Service Bulletin SB-4

June 22, 2004

SUBJECT

This service bulletin describes a swage cracking problem in McFarlane Part Number MC600-72 and MC600-120 vernier mixture controls and requires removal and replacement of controls with an affected lot number. Non-compliance could result in loss of mixture control authority and subsequent loss of engine power.

Figure 1: Mixture control housing with red knob.

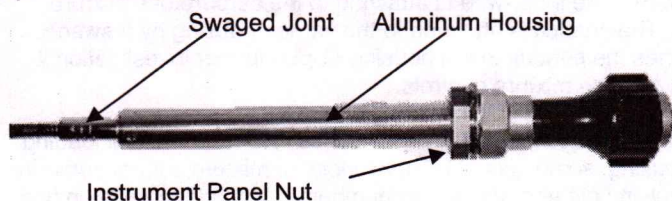
1. Search the aircraft's maintenance records for an entry indicating the installation of the affected part numbers and lot numbers listed above.
2. Visually inspect the vernier mixture control housing label. Look for the affected part numbers and lot numbers listed above.

Figure 2: Close up of a swage joint.

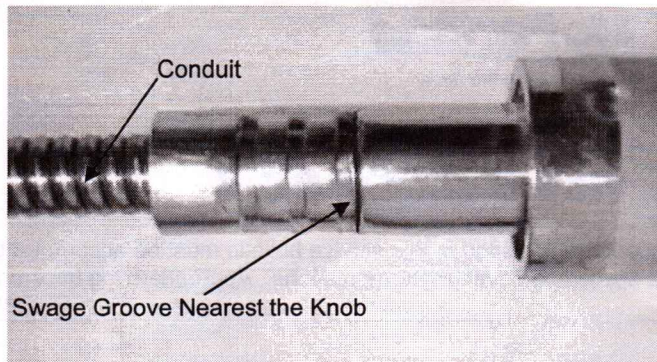
MC600-72 and MC600-120 are vernier mixture controls eligible for installation on many Cessna, Piper, Raytheon, Mooney, Maule and Univair (Stinson) carbureted single engine aircraft. The controls consist of a vernier housing that contains the vernier mechanism, a flexible conduit that guides the inner-wire to the carburetor, and an inner-wire. The inner-wire is attached to the carburetor's mixture arm, and the vernier housing is typically mounted in the instrument panel. The conduit is attached to the vernier housing by a swage. Recently, during production, cracks were detected in the swage that attaches the conduit to the housing. Upon further investigation it was concluded that the cracks may be present in previous production lots of these mixture controls.

The cracks in the swage joint will not affect the functioning of the control in most cases, but in extreme cases involving unusual loading of the mixture control and complete detachment of the conduit from the housing, some loss or complete loss of mixture control authority could occur, although there have been no reports of service difficulties involving either of these part numbers. McFarlane Aviation has changed the design in the area of the swaged joint to prevent cracking in current production parts. Due to the difficulty of detecting the cracks, McFarlane Aviation is requiring the removal and replacement of all controls with the affected lot numbers even though many of the MC600-72 and MC600-120 controls in service do not have cracks.

- 1) Remove the affected control from the aircraft.
- 2) Replace the affected control with a new MC600-72 or MC600-120 as applicable. Verify that the new control has a lot number greater than 11697. Install the new control per Drawing 1390 titled "McFarlane Aviation MC600 Series Solid Wire Vernier Fuel Mixture Control Installation Instructions" that is included with the new control or available from www.mcfarlaneaviation.com.
